# HISTORIC AND DESIGN REVIEW COMMISSION

June 16, 2021

**HDRC CASE NO:** 2021-100  
**ADDRESS:** 415 MISSION ST  
**LEGAL DESCRIPTION:** NCB 946 BLK 2 LOT 22  
**ZONING:** RM-4,H  
**CITY COUNCIL DIST.:** 1  
**DISTRICT:** King William Historic District  
**APPLICANT:** Jake Jazdzewski/JAZDZEWSKI JAKE & MONICA  
**OWNER:** Jake Jazdzewski/JAZDZEWSKI JAKE & MONICA  
**TYPE OF WORK:** Relocation of garage structure, modifications  
**APPLICATION RECEIVED:** May 18, 2021  
**60-DAY REVIEW:** Not applicable due to City Council Emergency Orders  
**CASE MANAGER:** Stephanie Phillips  
**REQUEST:**

# JAZDZEWSKI RESIDENCE RESIDENTIAL REMODEL

**3 FRONT ELEVATION - NEW IMPROVEMENTS**  
SCALE: 1/4" = 1'-0"

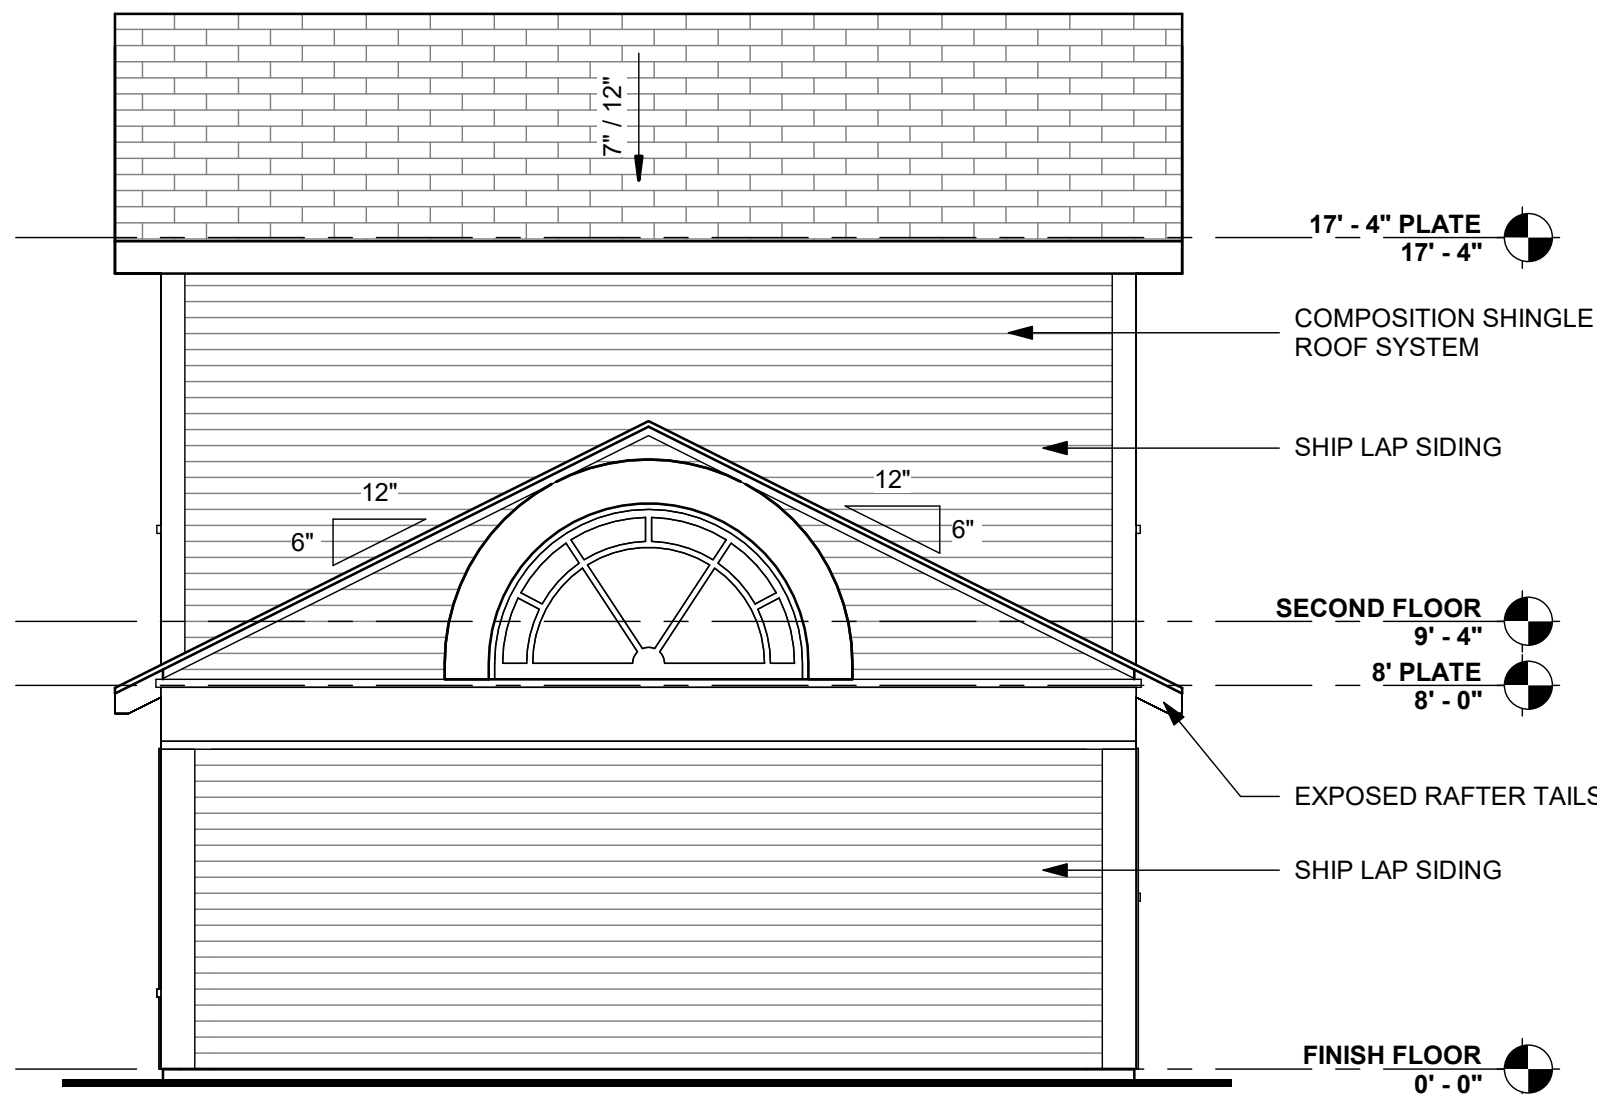
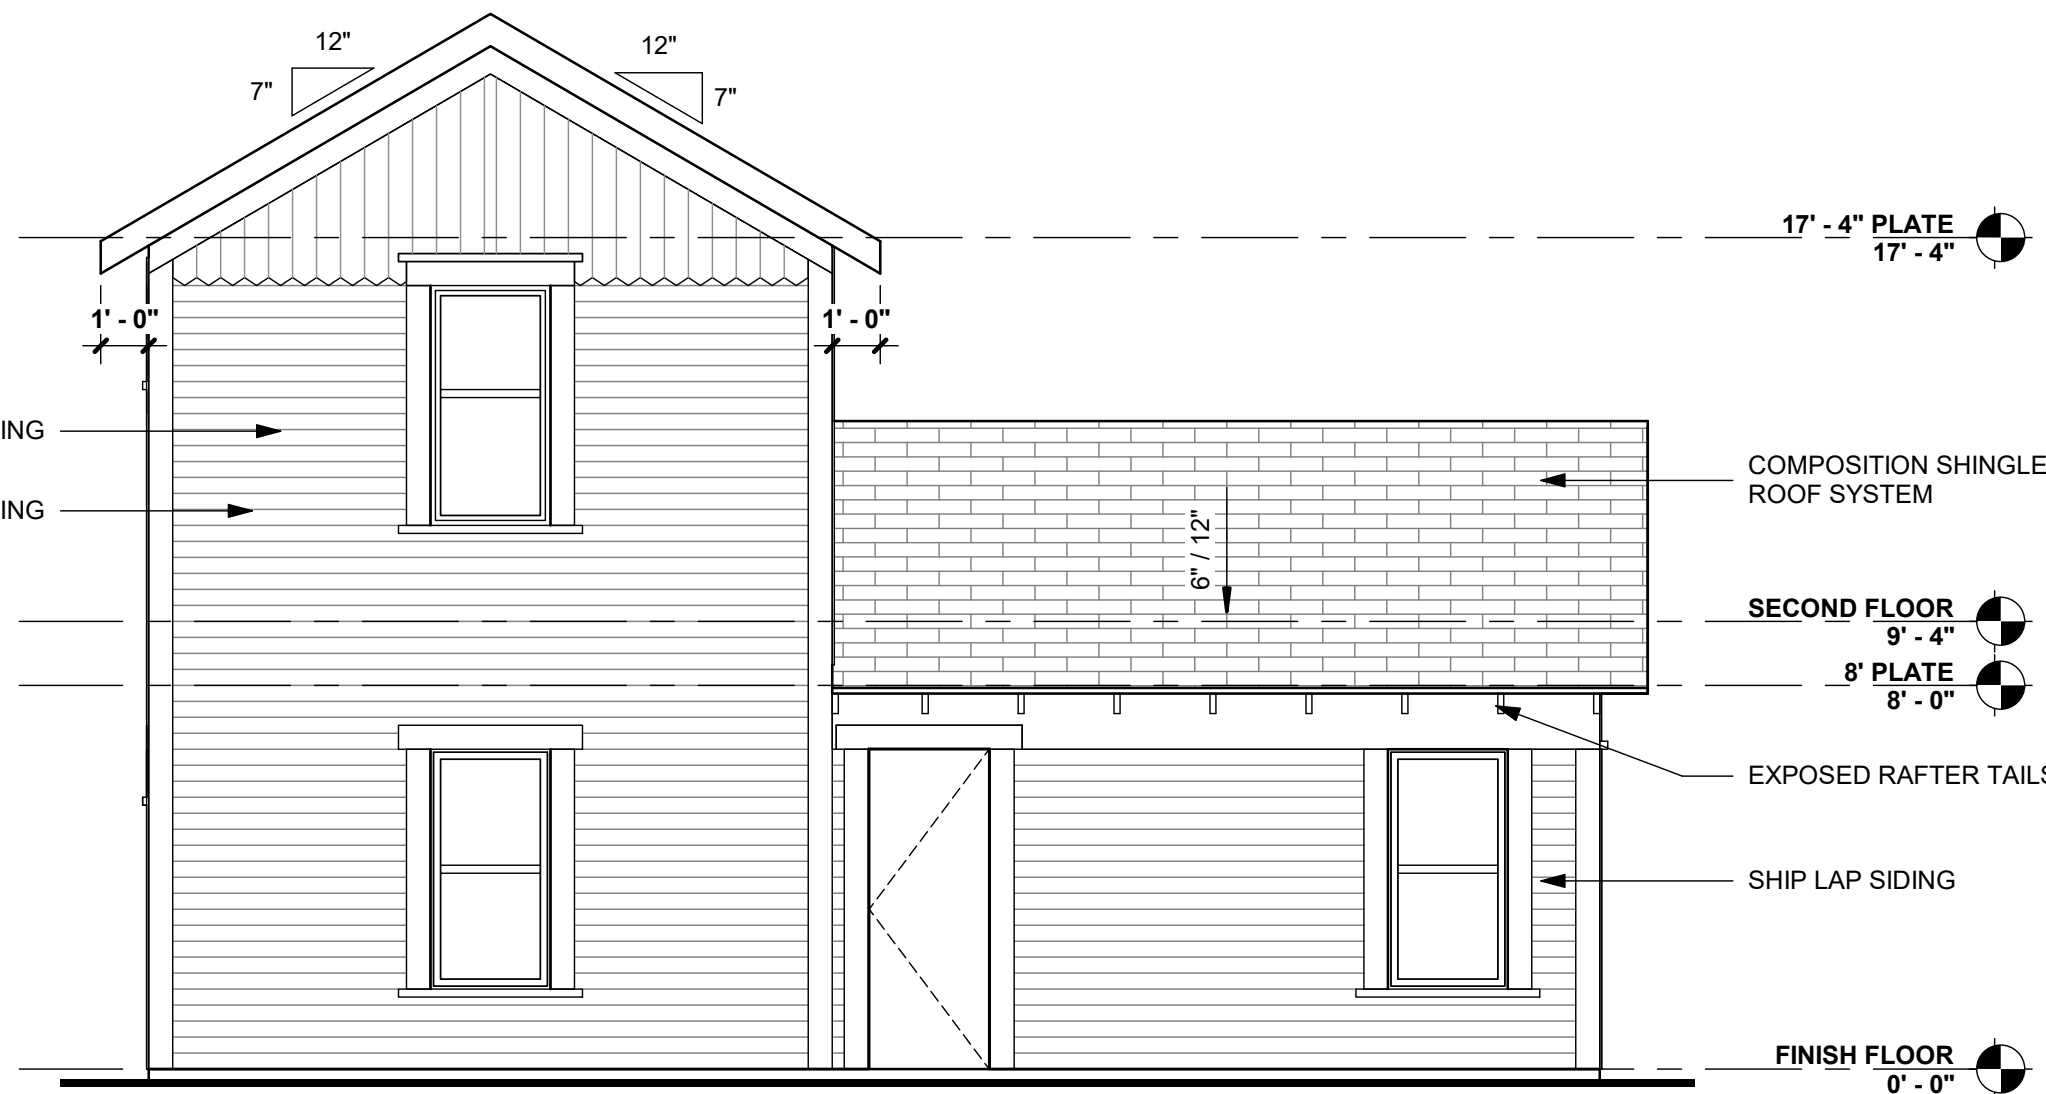
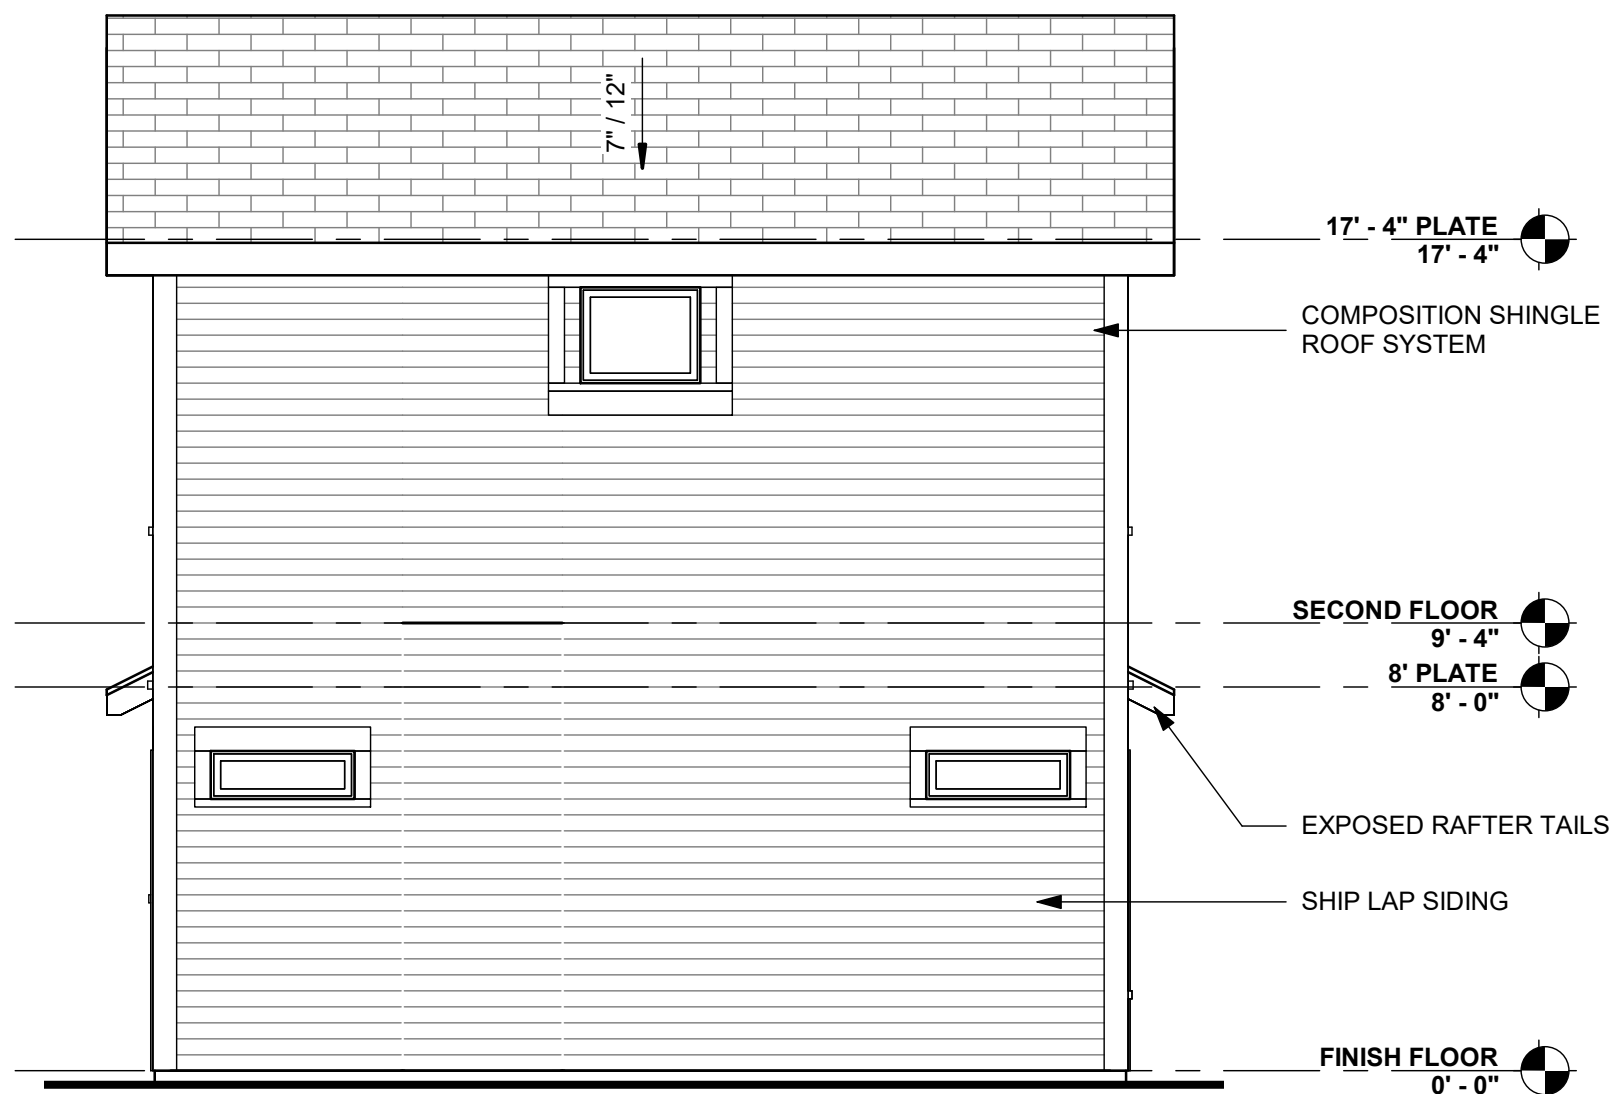
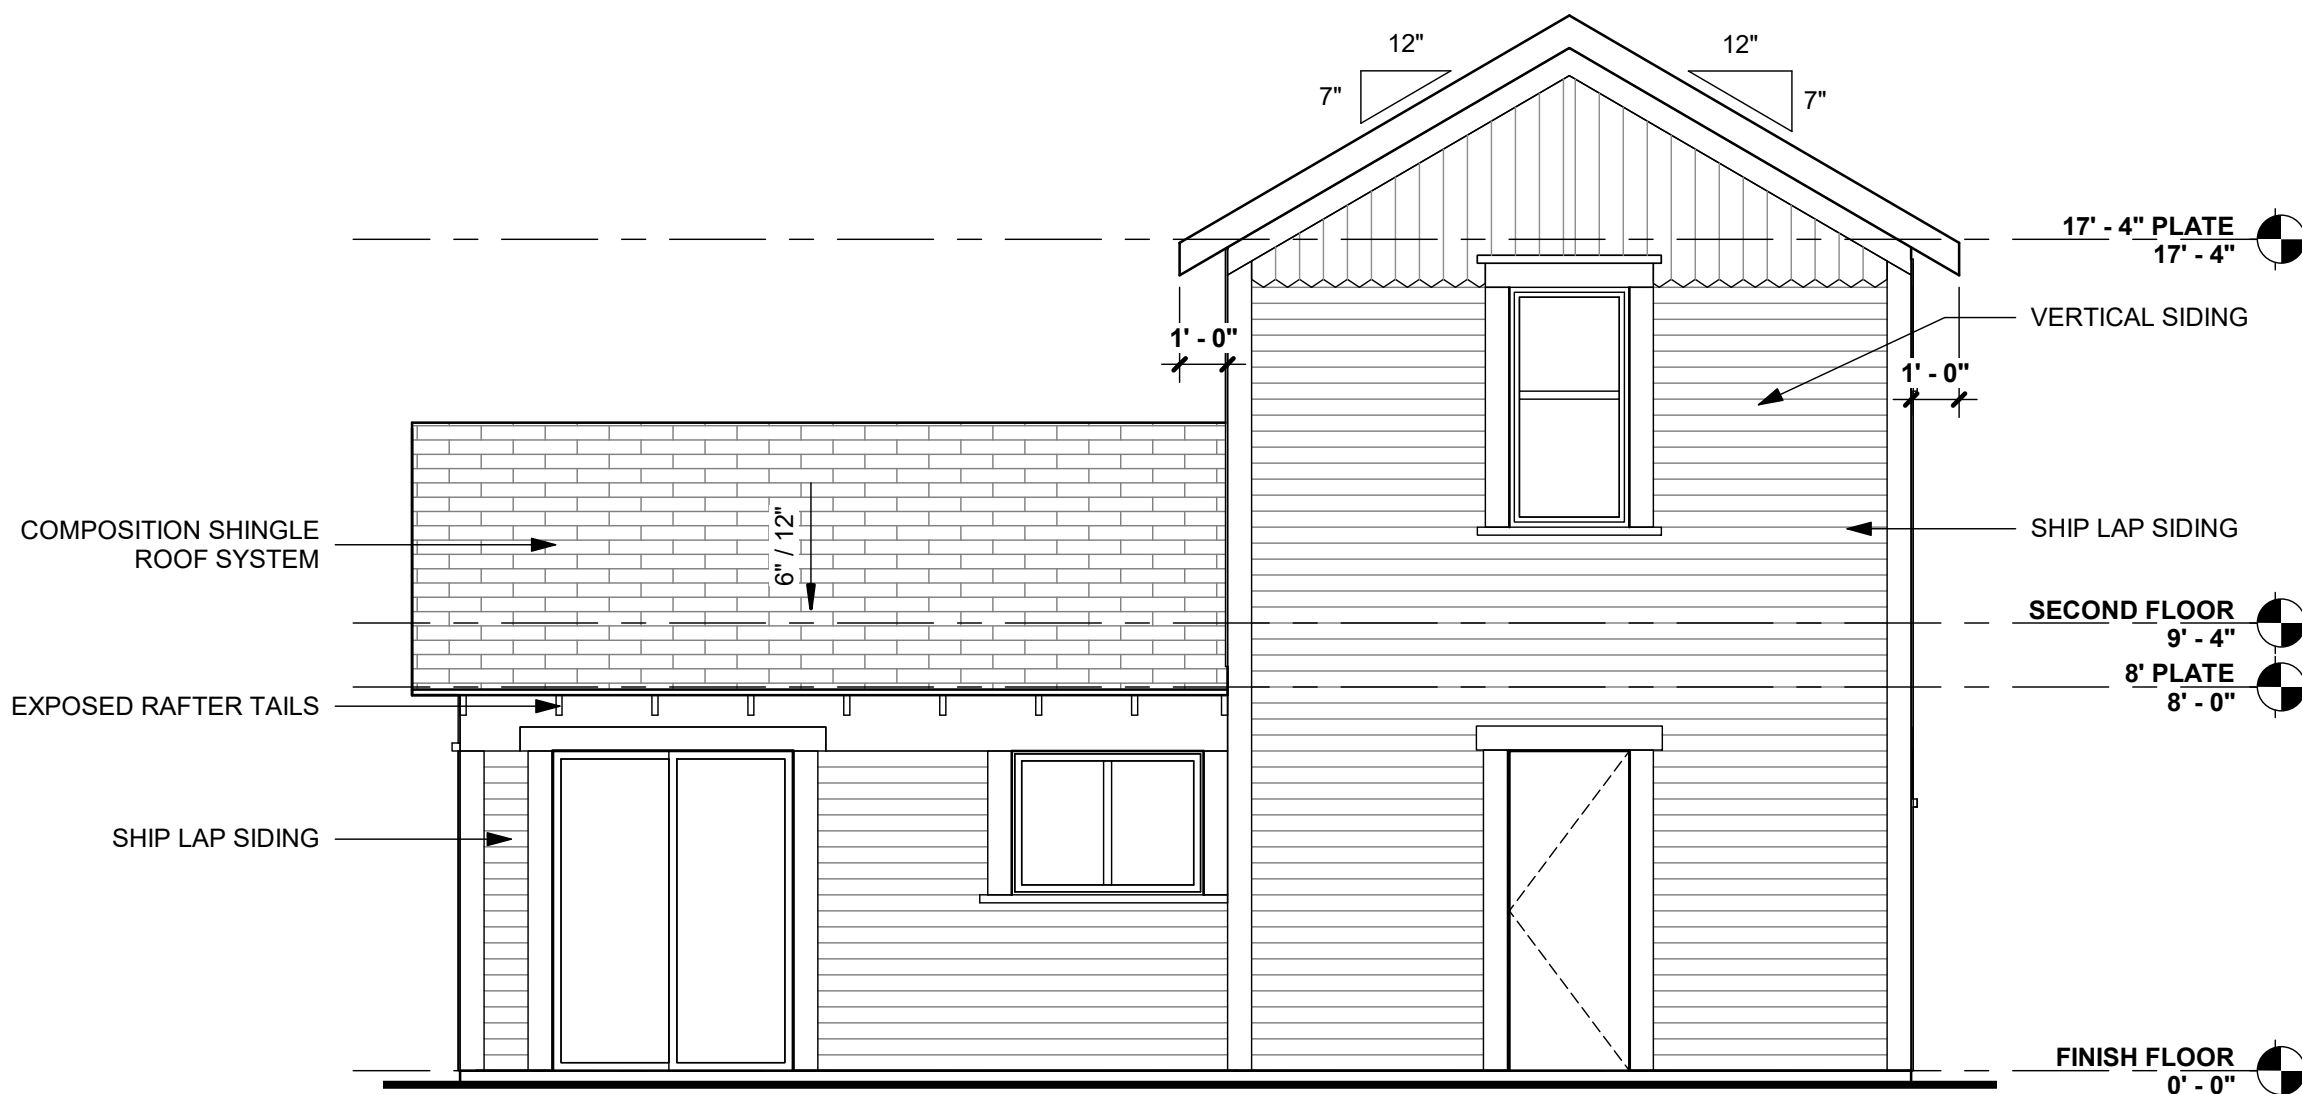
- e. FENESTRATION MODIFICATIONS – The applicant has proposed to replace an existing second story door at the stair landing with a new window to match existing in terms of scale, proportion, configuration, and inset. The awning above the door will also be removed. Staff generally finds the request appropriate, but finds that the door should be retained and reused elsewhere on the structure, or stored on the property. Additionally, the applicant has proposed to remove an existing first floor window and enclose with siding on the back elevation. An existing second story window on this elevation will be retained. Staff generally finds the request acceptable based on its limited visibility from the public right-of-way and the retention of an additional opening, but finds that the window should be retained and reused elsewhere on the structure, or stored on the property. Staff also finds the addition of new sliding doors on an ancillary elevation to be appropriate.

- f. GARAGE BAY ENCLOSURE – The applicant has proposed to enclose the open garage bay with siding to create interior space. The garage is the single story mass of the rear accessory structure and faces the primary structure. The garage does not serve a driveway, rear alley, or other parking access or configuration and is located to the west of the driveway in the rear yard. Staff finds the enclosure of the garage bay acceptable due to its limited visibility from the public right-of-way and the fact that the remaining elements of the structure, including all walls, the front half circle window, and the vertical trim pieces, will be retained, rendering the intervention reversible.

- j. **WINDOW REPLACEMENT** – The applicant has proposed to replace all existing windows with new aluminum clad wood windows per the submittal documents. According to the Historic Design Guidelines, wood windows should be repaired in place and restored whenever possible, unless there is substantial evidence that the windows are deteriorated beyond repair. If a window assembly is deemed irreparable, the window should be replaced in-kind in terms of materiality, configuration, inset, proportion, style, and detailing. As noted in finding g, staff finds that the windows are in repairable condition, with a majority of them being covered and protected over the past few decades by exterior screens. Staff does not find replacement consistent with the Guidelines.

- i. That the applicant restores all wood windows in the openings that are not proposed to be modified as noted in findings g through j. The applicant is required to submit updated drawings that reflect the window retention to staff prior to the issuance of a Certificate of Appropriateness.

- ii. That all new windows to be installed in new openings or where non-original windows exist meet the following stipulations: the windows should be wood or fully wood and feature an inset of two (2) inches within facades and should feature profiles that are found historically within the immediate vicinity. Meeting rails must be no taller than 1.25" and stiles no wider than 2.25". White manufacturer's color is not allowed, and color selection must be presented to staff. There should be a minimum of two inches in depth between the front face of the window trim and the front face of the top window sash. This must be accomplished by recessing the window sufficiently within the opening or with the installation of additional window trim to add thickness. Window trim must feature traditional dimensions and architecturally appropriate sill detail. Window track components must be painted to match the window trim or concealed by a wood window screen set within the opening.
